TEAC TECHNICAL INFORMATION

TASCAM MMC-38, Change of the Software

TASCAM DA-38/88/98, Impedance Roller Height Adjustment

TASCAM DA-38/88/98, Changes on Mechanism (S-Err 08/31)

Cause :

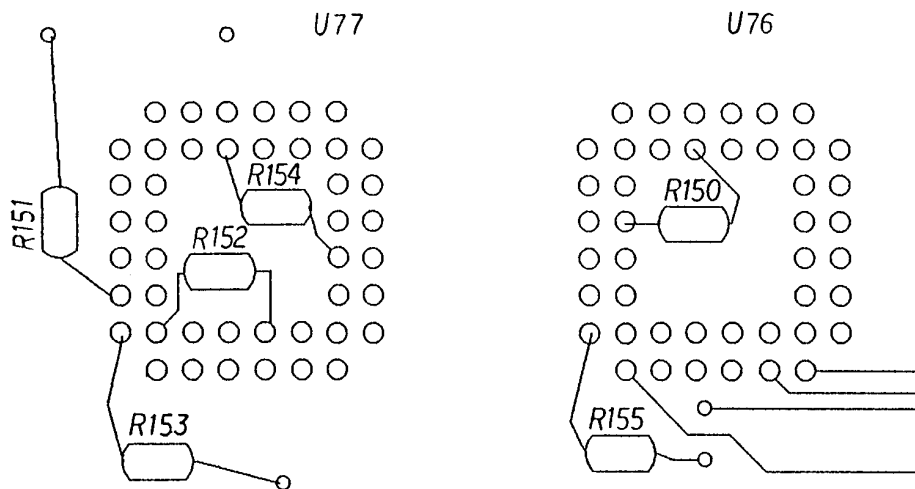
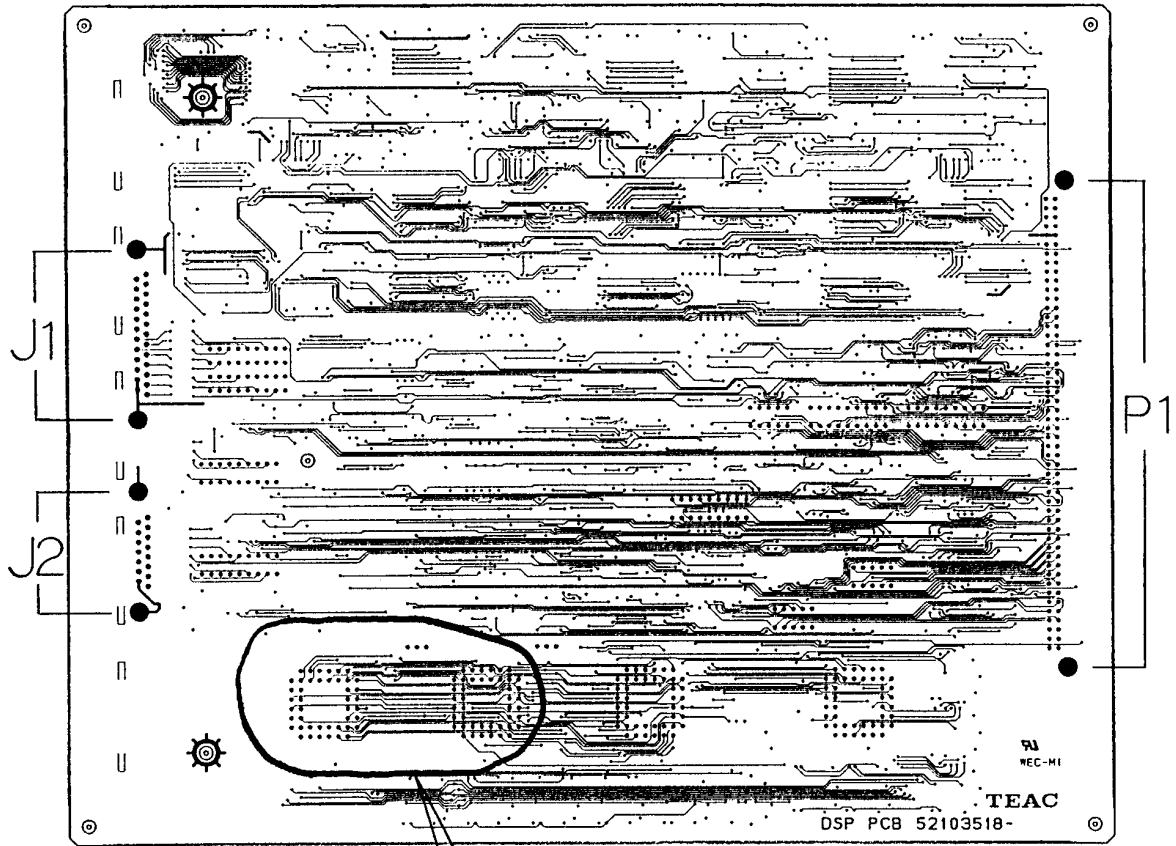
At the moment of power ON, Pins 18 through 23 of U47 IC on the DSP PCB Assy go high state falsely. This will make the system Rec Enable state.

[OPERATION PCB ASSY]

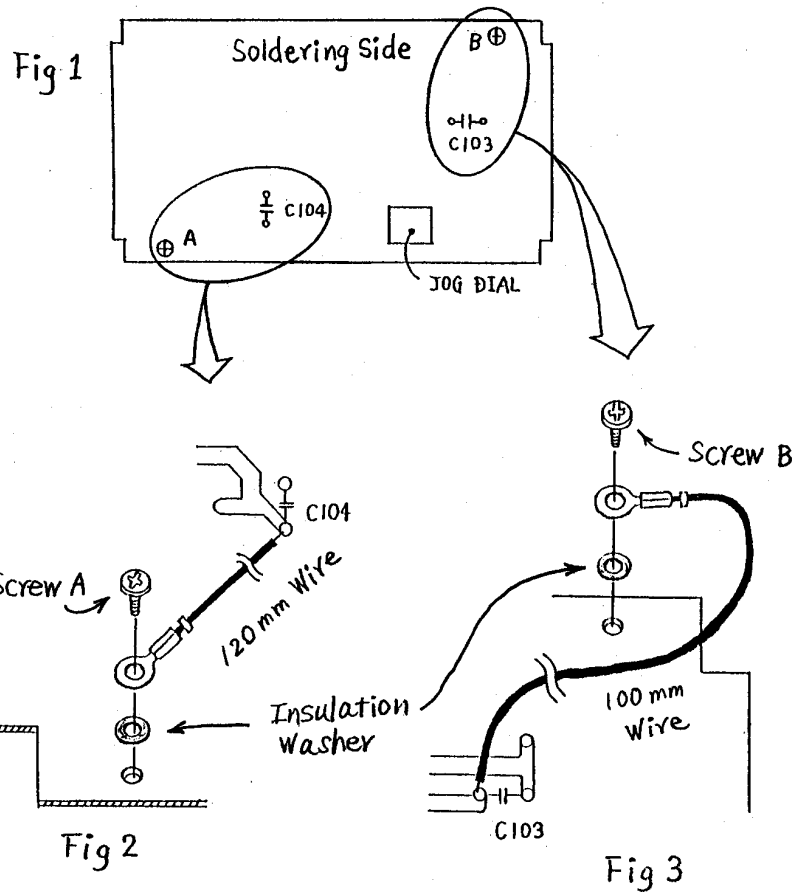
- d. Prepare 120 mm Jumper wire of which one end terminated with an earth lug. Remove Screw A which fix the PCB Assy. Place an insulation washer on the PCB hole of Screw A. Place the earth lug of Jumper wire on the washer. Tighten earth lug, washer and PCB altogether with Screw A. Then solder another end of Jumper wire to the C104 GND side. See Fig 1 and 2.
- e. Prepare 100 mm Jumper wire of which one end terminated with an earth lug. Remove Screw B which fix the PCB Assy. Place an insulation washer on the PCB hole of Screw B. Place the earth lug of Jumper wire on the washer. Tighten earth lug, washer and PCB altogether with Screw B. Then solder another end of Jumper wire to the C103 GND side. See Fig 1 and 3.
